#### Orchard Run/Courts of Clarksburg, Local Map Amendment, LMA G-881, Preliminary Forest Conservation Plan and Preliminary Water Quality Plan

Staff Report Date: 12/7/2012

> Re: **Preliminary** Water Quality Plan for Orchard Run-the Courts at Clarksburg SM File #: 235362 Tract Size/Zone: 54.4 Ac./PRC Watershed: Little Seneca Creek

Attachment B: Impervious Area Exhibit, July 2012

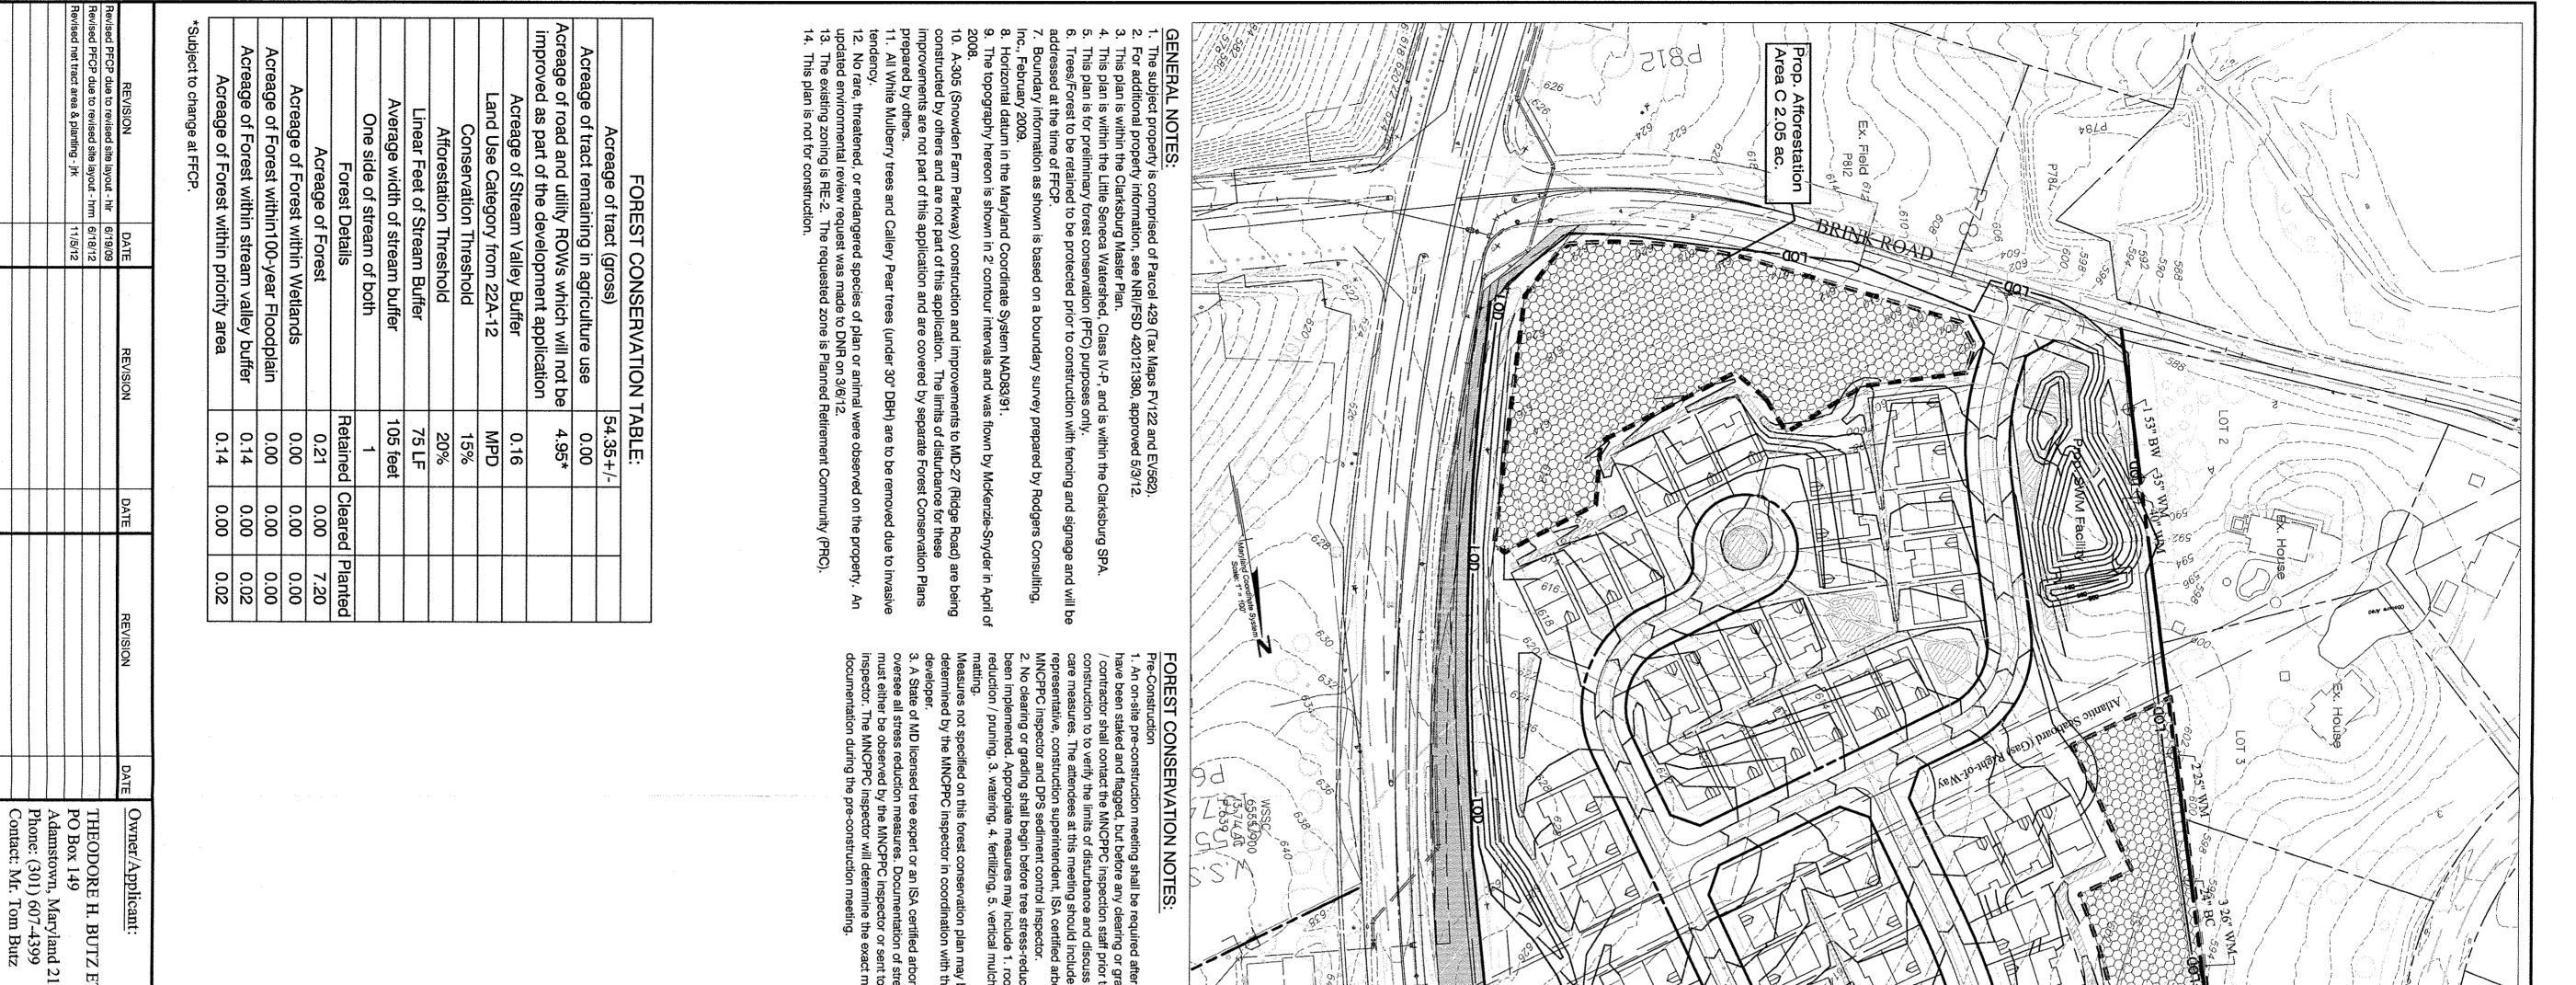
The Applicant on the July, 2012 Impervious Area Exhibit proposes a post development condition of 12.63 acres of impervious surfaces, or 25.6% of the 49.4 net tract area (See Attachment B). The net tract area of 49.4 is equal to the total tract area of 54.35 minus the proposed Right-of-Way dedication of 4.95 acres.

MNCPPC staff has additionally recommended a condition of approval of the Preliminary WQP that impervious levels not exceed of 26% on the 49.4 acres. The 26% impervious surface rate condition was selected for the Preliminary WQP based upon drawing that the applicant submitted showing the project could achieve 25.6% of 49.4 acres. An additional 0.4% of the 49.4 acres was added to allow some flexibility within the Preliminary WQP approval.

- 2) The impervious surfaces on the Subject Property are limited to no more than 26 percent of 49.4 acres of land within the SPA as shown on the Impervious Surface Plan dated July, 2012 portion of the Preliminary Water Quality Plan.
